Illinois Tollway Base Sheet Revisions			
Section M	Base Sheet Drawings		
	Drawing	Modification Summary	Effective: 03-31-2016
	All	The electronic (pdf) version of the Standard Drawing are now made searchable (text).	
Erosion Sediment Control (ESC)-Series 200			
M-ESC-205	Sediment Basin Dewatering Device		
	Revised Note 7, removed proprietary name from skimmer device.		
Roadway (RDY)-Series 400			
M-RDY-408	Approach Slab, Mainline		
All	Changed Transverse Reinforcement size and spacing in the bottom mat of the bridge approach slab and transition approach shoulder slabs from #6@9" to #8@4" to be in conformance with IDOT ABD Memo 15.8.		
All	Changed Transverse Reinforcement size and spacing in the top mat of the bridge approach slab and transition approach shoulder slabs from #5@12" to #5@6" to be in conformance with IDOT ABD Memo 15.8.		
All	Changed Longitudinal Reinforcement size and spacing in the top mat of the bridge approach slab and transition approach shoulder slabs from #4@15" to #5@6" to be in conformance with IDOT ABD Memo 15.8.

Tollway Base Sheet Revisions		
Section M	Base Sheet Drawings	
	Drawing	Modification Summary Effective: 03-31-2016
	Maintenance of Traffic (MOT)-Ser

SHEET 4 OF 5  
BASE SHEET M-RDY-408

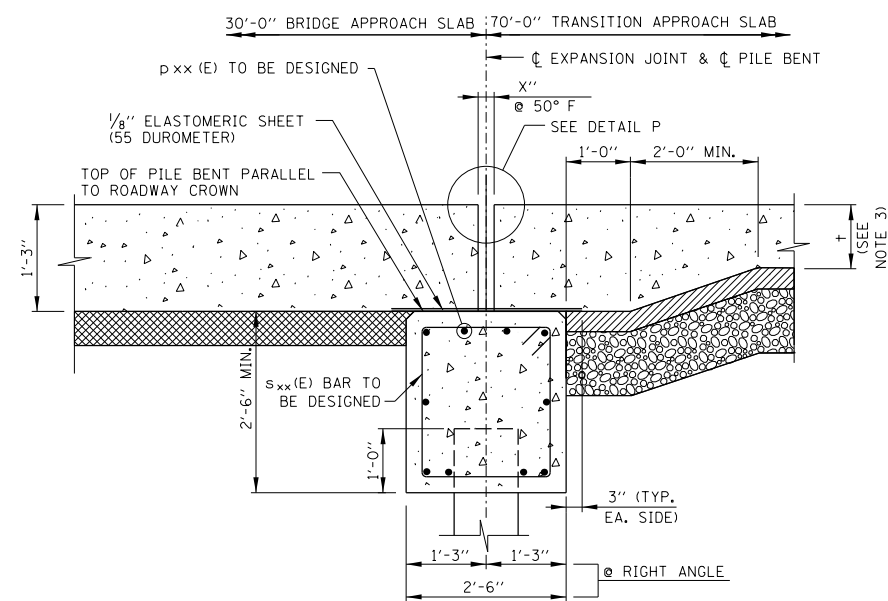
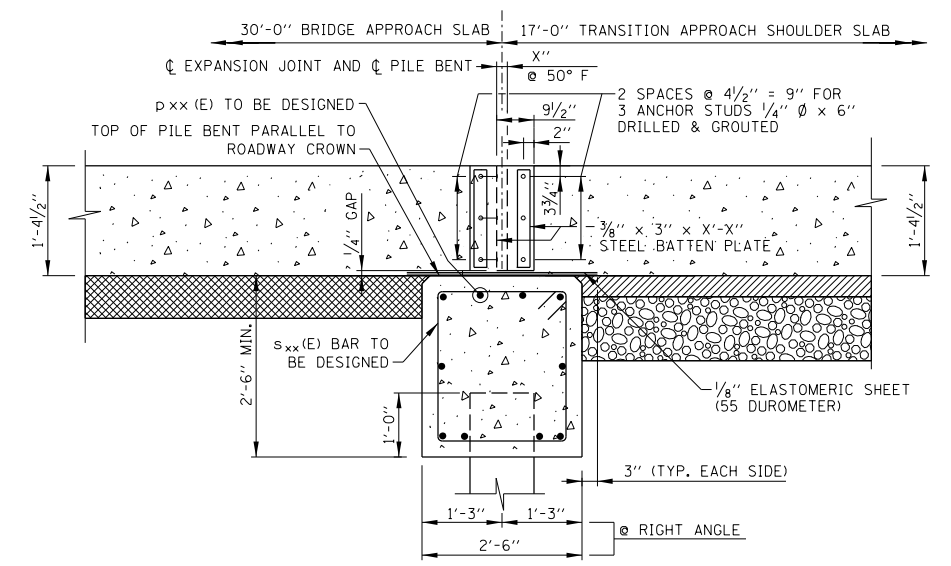
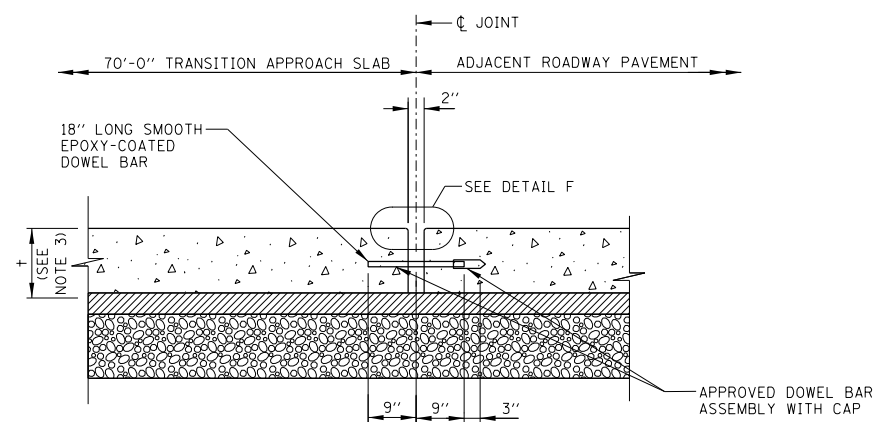
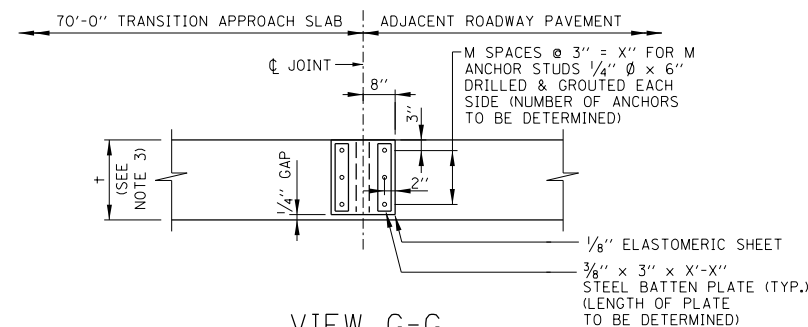
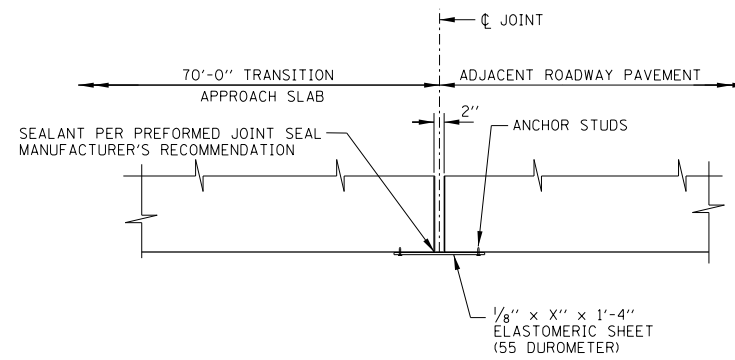
Sheet 3	Eliminated Optional Longitudinal Joint Within a Traffic Lane detail.		
Sheet 4	Changed Neoprene Sheet to Elastomeric Sheet to keep call out generic and not specific.

Sheet 3	Eliminated Optional Longitudinal Joint Within a Traffic Lane detail.		
Sheet 4	Changed Neoprene Sheet to Elastomeric Sheet to keep call out generic and not specific.

SHEET 5 OF 5  
BASE SHEET M-RDY-408

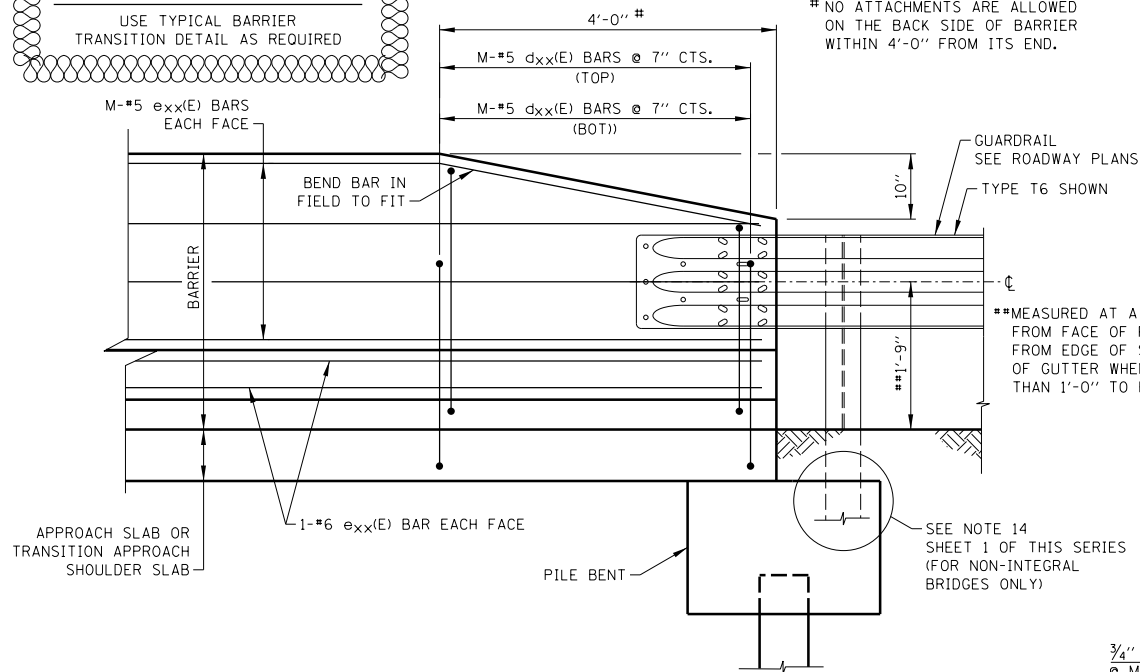
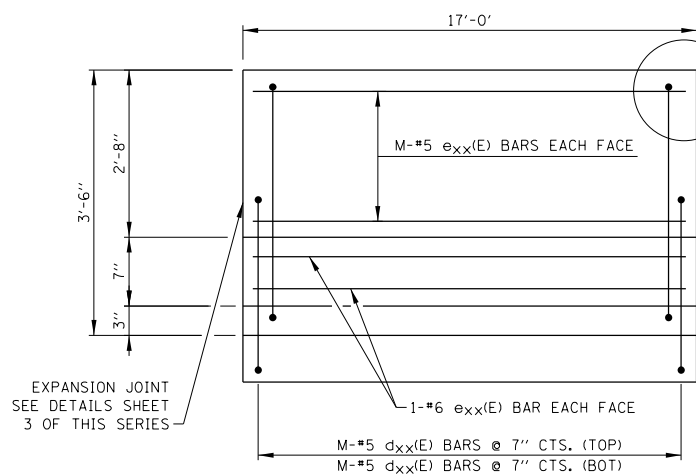
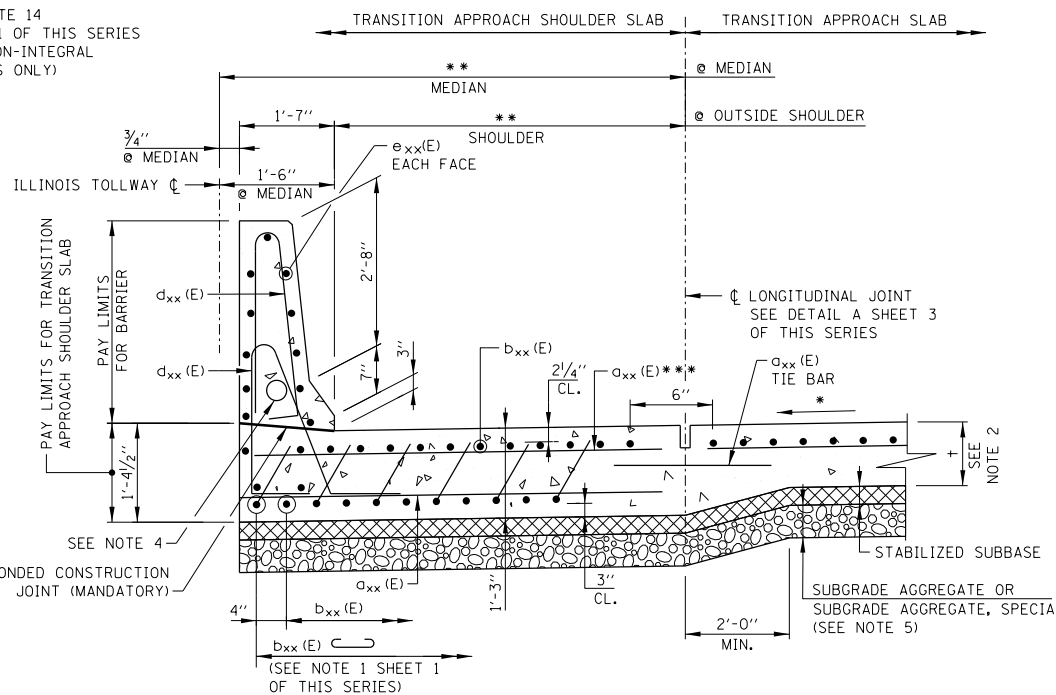
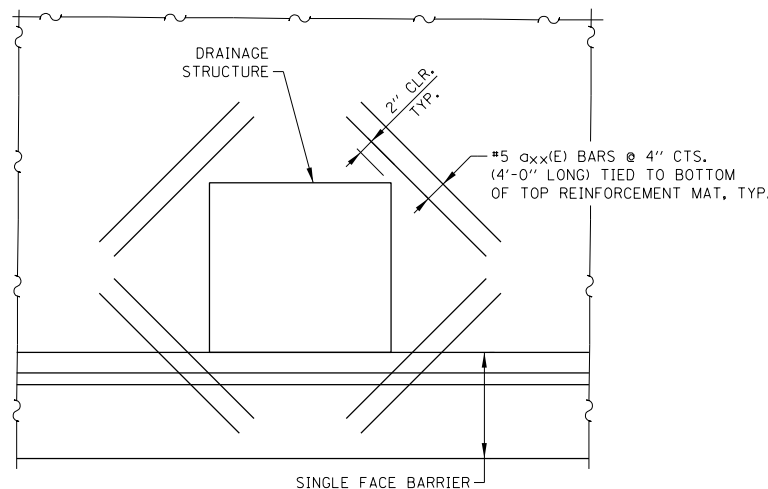
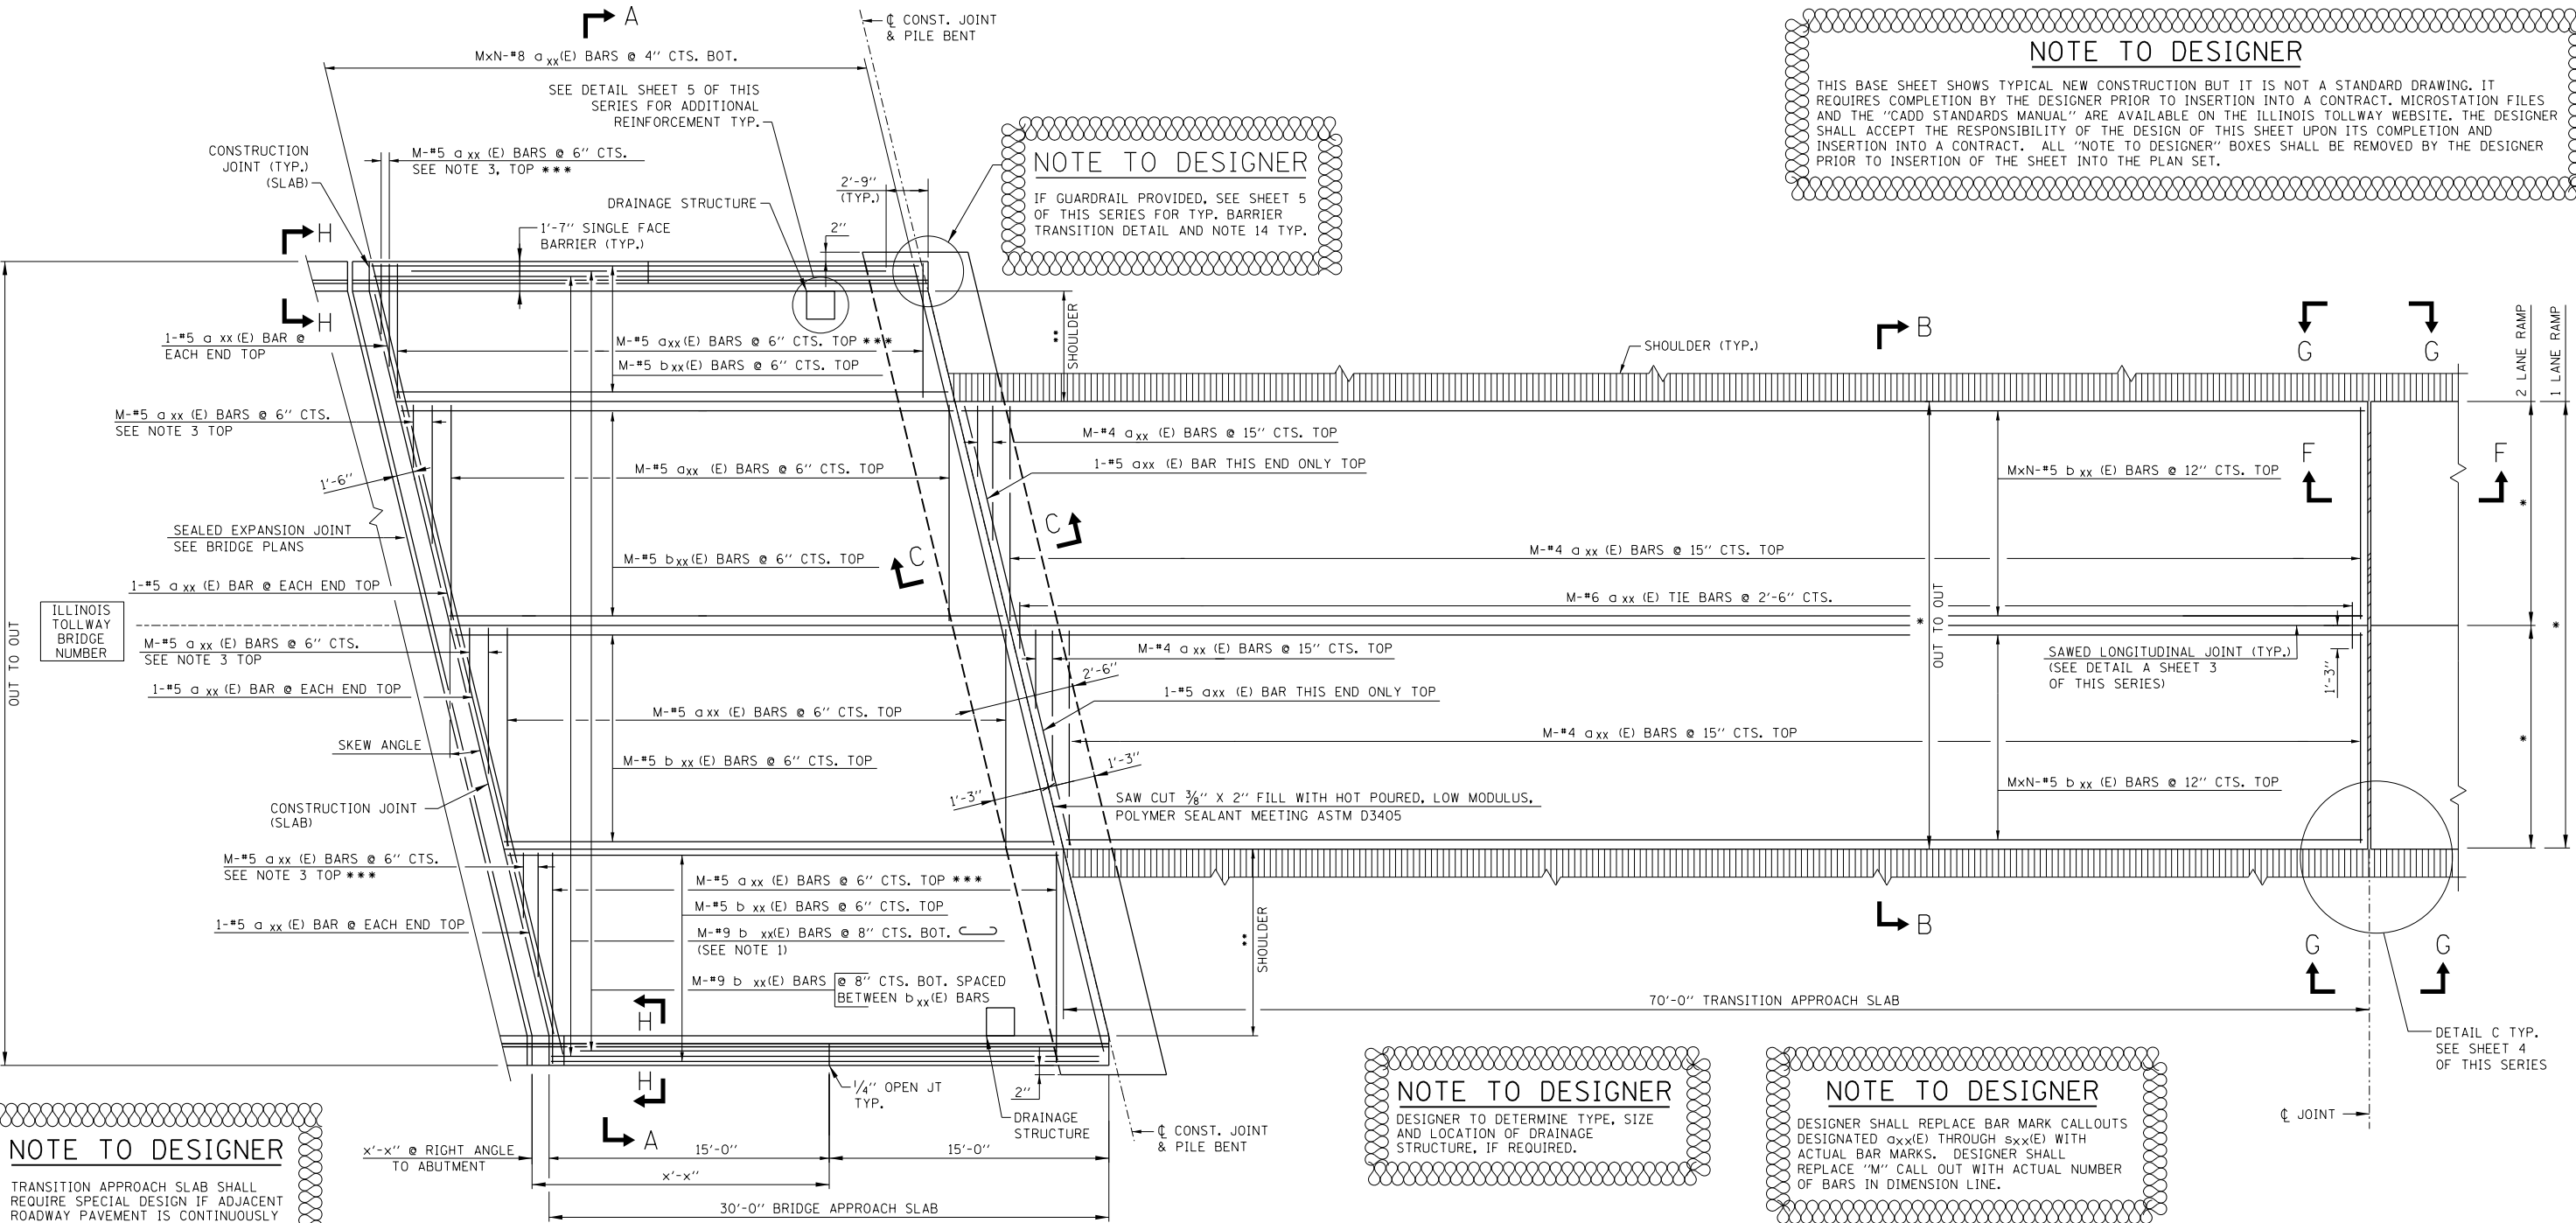
Sheet 5	Revised Bill of Material to clarify Pay Items and Pay Item Numbers to be included.		
Sheet 5	Added note to Typical Barrier Transition Detail to clarify where the 1'-9" dimension should be measured.		
M-RDY-409	Approach Slab, Ramp		
All	Changed Transverse Reinforcement size and spacing in the bottom mat of the bridge approach slab and transition approach shoulder slabs from #6@9" to #8@4" to be in conformance with IDOT ABD Memo 15.8.		
All	Changed Transverse Reinforcement size and spacing in the top mat of the bridge approach slab and transition approach shoulder slabs from #5@12" to #5@6" to be in conformance with IDOT ABD Memo 15.8.		
All	Changed Longitudinal Reinforcement size and spacing in the top mat of the bridge approach slab and transition approach shoulder slabs from #4@15" to #5@6" to be in conformance with IDOT ABD Memo 15.8.		
All	Added note *** to clarify that base sheet reinforcement is for approach slabs not located on retaining walls. If approach slab is placed on retaining wall, reinforcement shall be designed for TL-5 crash loading.

Sheet 5	Revised Bill of Material to clarify Pay Items and Pay Item Numbers to be included.		
Sheet 5	Added note to Typical Barrier Transition Detail to clarify where the 1'-9" dimension should be measured.		
M-RDY-410	Reserved		
M-RDY-411	Emergency Turnaround Median Width ≥ 35 Ft		
Bridge (BRG)-Series 500			
M-BRG-506	Expansion Joint Repair		
	Base Sheet was removed since details did not match Special Provision.		
M-BRG-507	Crash Wall Modifications Median Piers		
	Note 4 - Changed Reinforcing bars to Reinforcement Bars.		
M-BRG-508	Crash Wall Modifications Shoulder Piers		
	Note 4 - Changed Reinforcing bars to Reinforcement Bars.		
M-BRG-525	Slopedwall Details		
Drainage (DRN)-Series 600			
M-DRN-601	Slope Drain		
	Revised storm sewer to "Class B, 12".		
M-DRN-602	Bioswale
